**Community Development Department – Planning Division**

#### REPORT TO DESIGN REVIEW BOARD

SUBJECT: 800 Mission Ave. ("Aegis Living San Rafael") – Review final details on the upper-story stepback along the Mission Avenue elevation, the landscaping of all outdoor common areas (patios and terraces), and the articulation to the north elevation of an approved 103-room/105-bed residential care facility with memory care services located on two vacant parcels at the northwest corner of Lincoln and Mission Ave. A Use Permit and an Environmental and Design Review Permit were approved for the project, subject to conditions, on October 12, 2021; APNS: 011-184-08 & -09; Multifamily Residential – High Density (HR1) District Zone; Geoff

Upper-Story Stepback

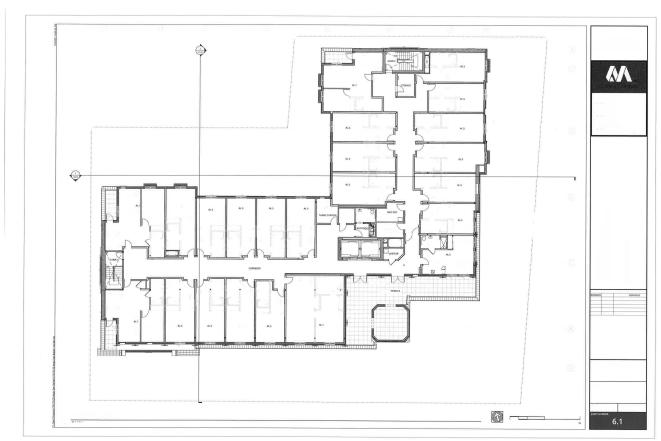
**Board Recommendation**. Provide additional stepback of the upper-story along the Mission Ave elevation.

**Staff's Comments.** The project has been redesigned to provide greater stepback of the upper-story along the Mission Ave. elevation. The previous design provided primarily a 2-foot stepback of the 5<sup>th</sup> floor along the Mission Ave. elevation. The redesign pulls back a majority of the residential rooms 8 feet from the building edge to create private terraces. This is in addition to the previous removal of two residential rooms to stepback the upper-story away from the dome tower feature and create a new common outdoor terrace on the 5<sup>th</sup> floor.
